TO:	CHAIR AND MEMBERS – PLANNING & ENVIRONMENT COMMITTEE
FROM:	GEORGE KOTSIFAS, P.ENG MANAGING DIRECTOR, DEVELOPMENT & COMPLIANCE SERVICES & CHIEF BUILDING OFFICIAL
SUBJECT:	APPLICATION BY: FUTURESTREETS INC. 164 SHERWOOD FOREST SQUARE PUBLIC SITE PLAN MEETING MAY 19, 2015

The purpose of this application is to obtain site plan approval for six (6) apartment buildings, each four (4) storeys in height with a total of 147 residential units at 164 Sherwood Forest Square. The application is to be heard at public meeting of the Planning and Environment Committee. The site contains a holding provision (h-5) to require a public site plan review.

Site Plan

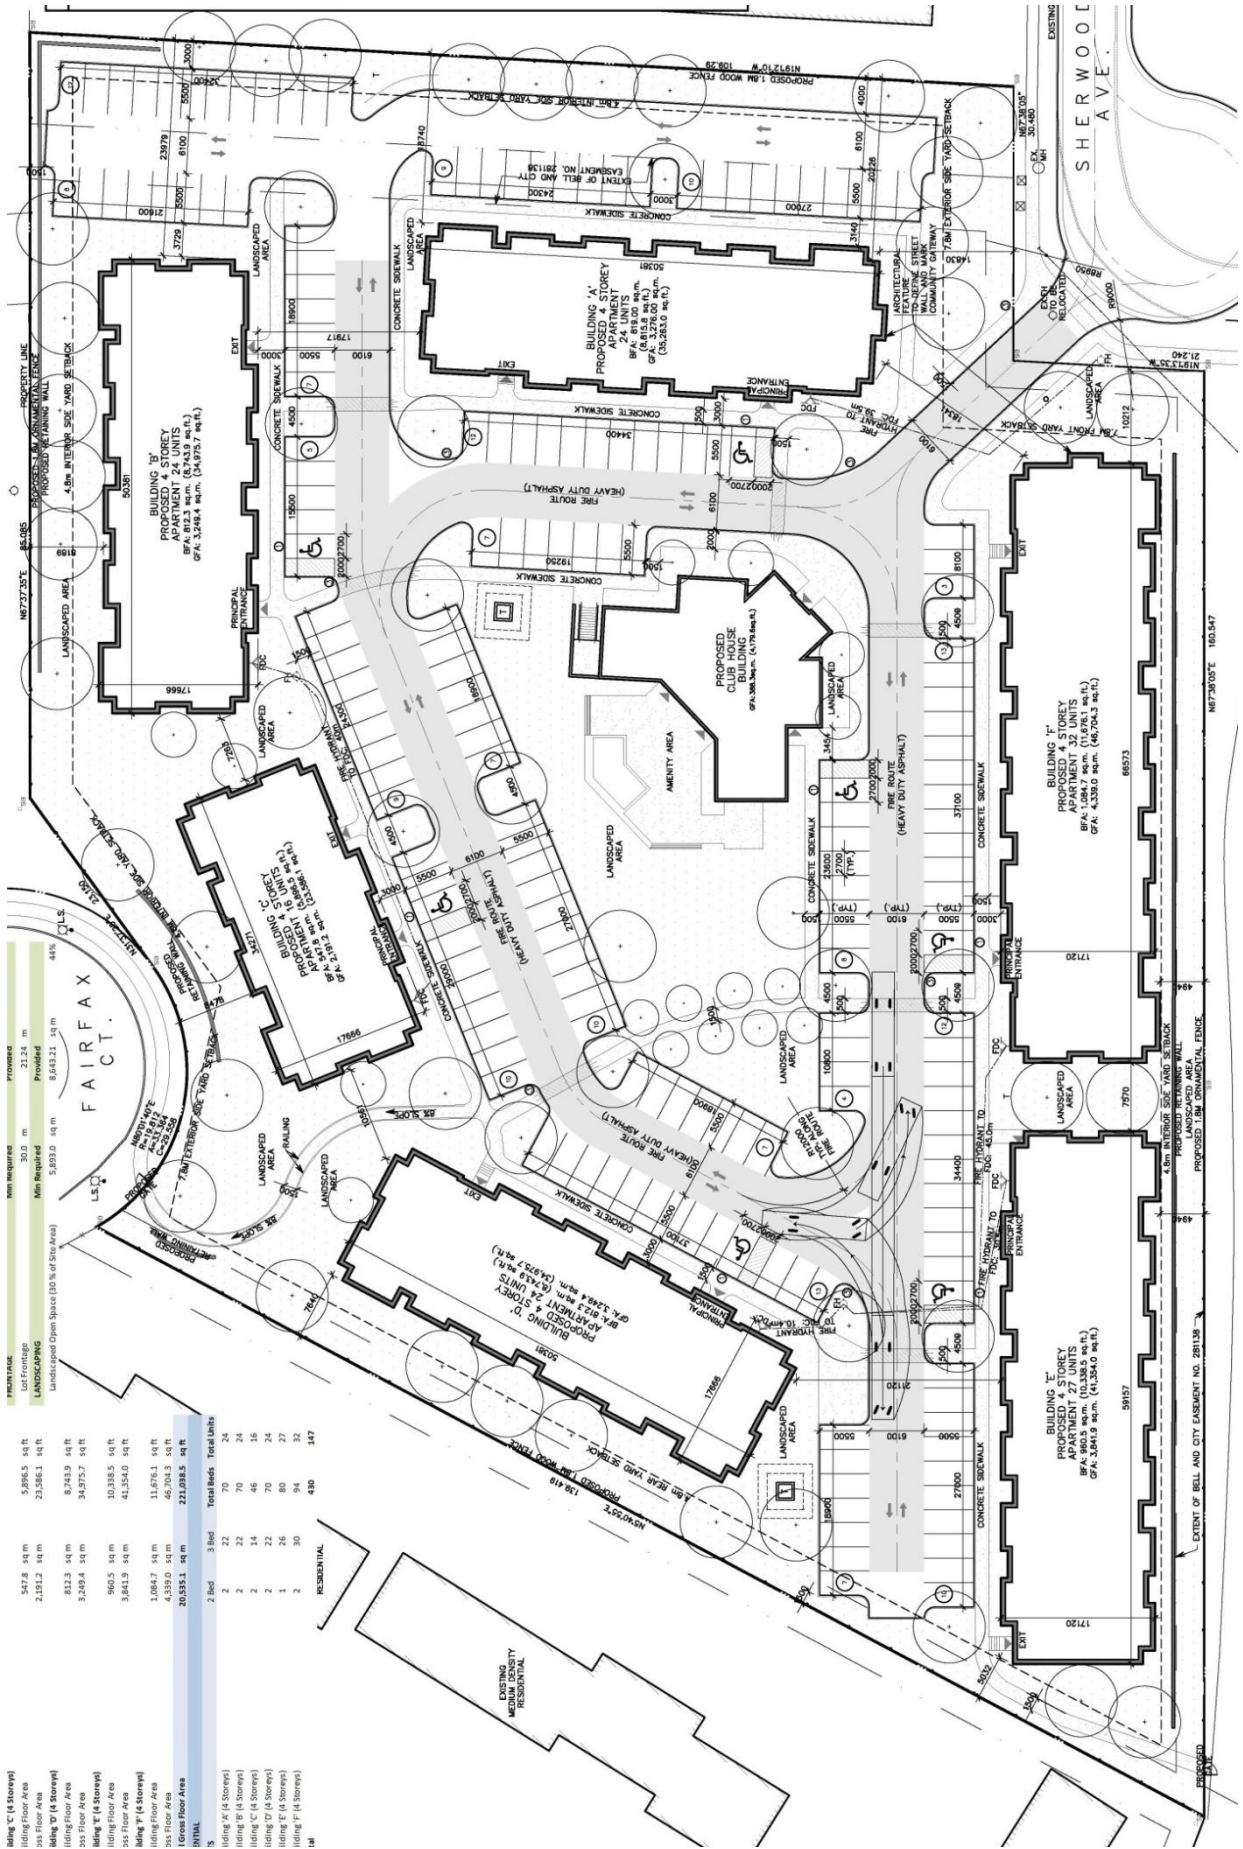
- Elevations for the 'clubhouse' building are required and confirm it is "accessory" (max height is 4m);
- Add notes to the site plan identifying "snow storage areas"

- Provide a mix of coniferous and deciduous trees around the periphery abutting the existing residential properties;
- Provide conifers at the end of the western drive aisle to soften the effect of headlights;

- Provide large canopy trees along south property line;
- Revise fencing detail to have 6' of privacy fencing with lattice along shared property lines with existing residential;

- Remove the fence along Fairfax court and use plant materials to delineate the property;
- Add boulevard trees along the property frontage along Fairfax Court. (note: consensual boulevard tree removal required for removal of street trees along Fairfax Court);

- Consider providing a walkway from the clubhouse patio to the internal walkways rather than having to access the patio from through the building. Confirm the use of "Clubhouse" and how it is accessory and add a note to the site plan "accessory structures to comply with section 4";

- Show the walkway connections to the south on all plans including the gate;
- Enter into cost-sharing agreement for Sherwood Forest Square improvements;

West and South Building Elevations

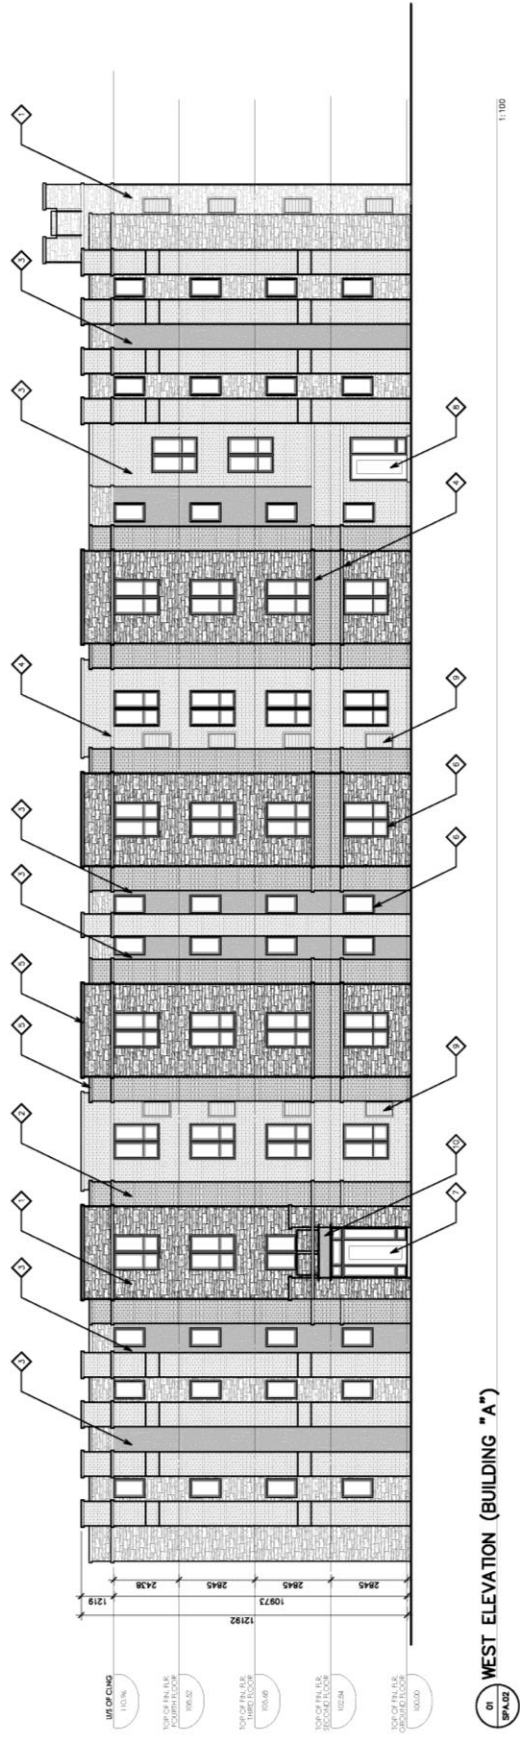
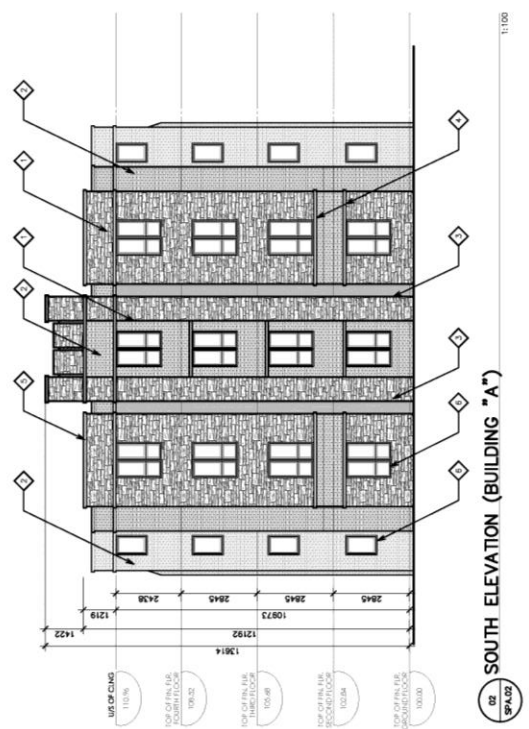
Height elements were added to the building elevation to architecturally address the terminal view along Sherwood Forest square. Steel canopies are proposed above the main building entrances.

Sherwood Forest Square Improvements

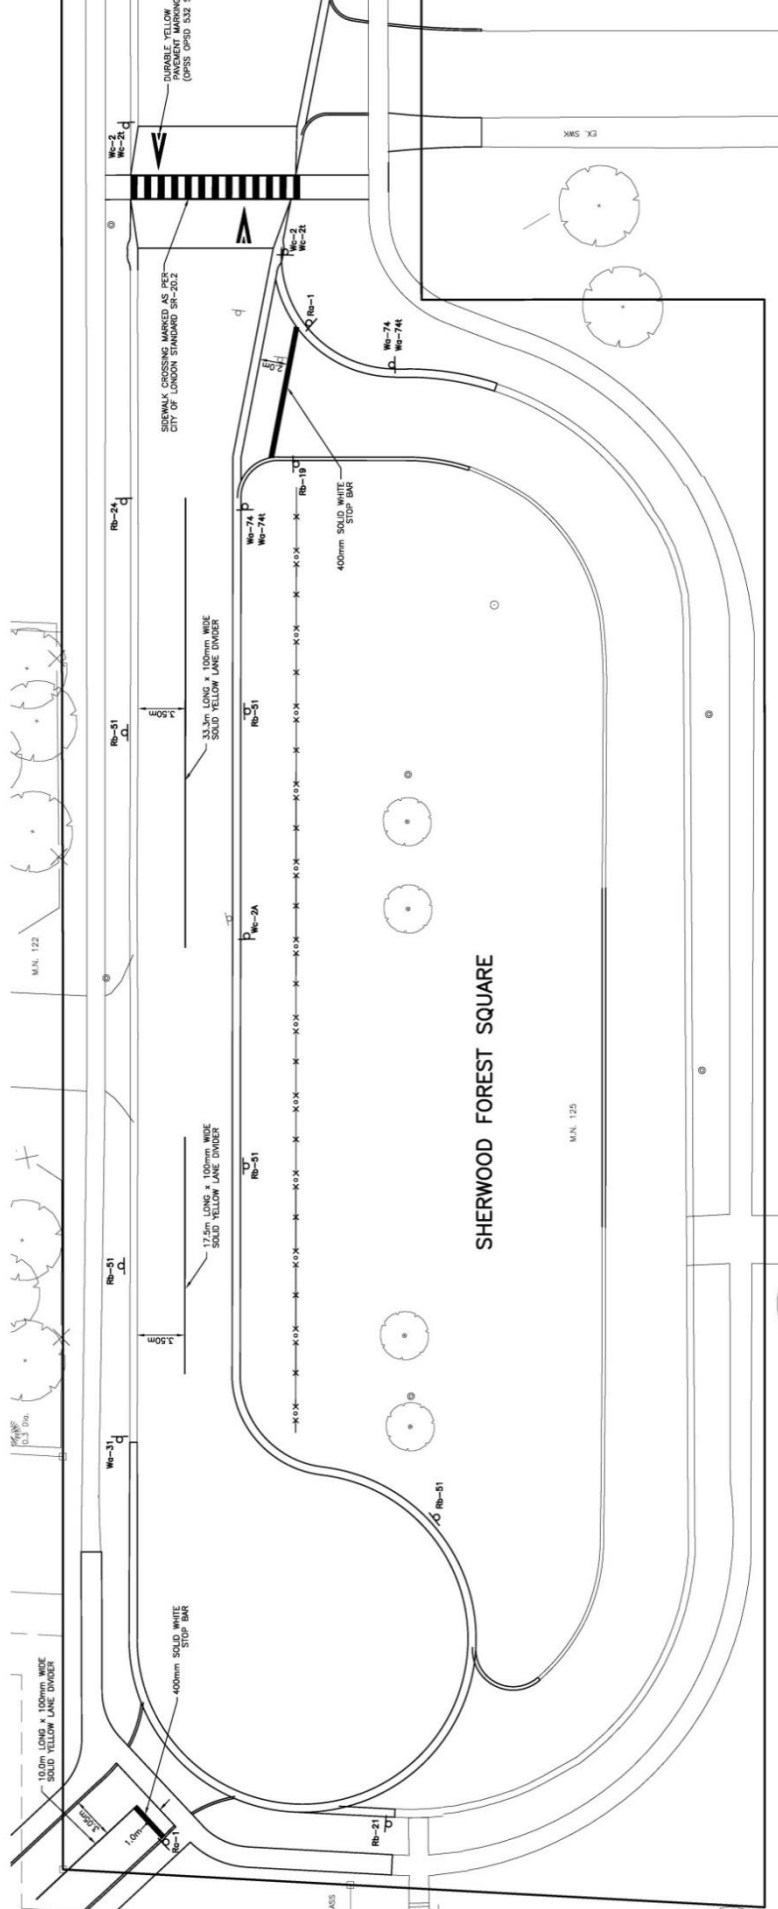
Please update the signage for the raised pedestrian crosswalk.

An additional Rb-19 sign is required on the east side of the one way exit.

3.0 m flat section required on the top of the raised pedestrian crosswalk.

Catchbasins cannot be connected by a lead to another catchbasin (catchbasin adjacent to the raised pedestrian crosswalk).

Additional tree plantings are required in the center island.
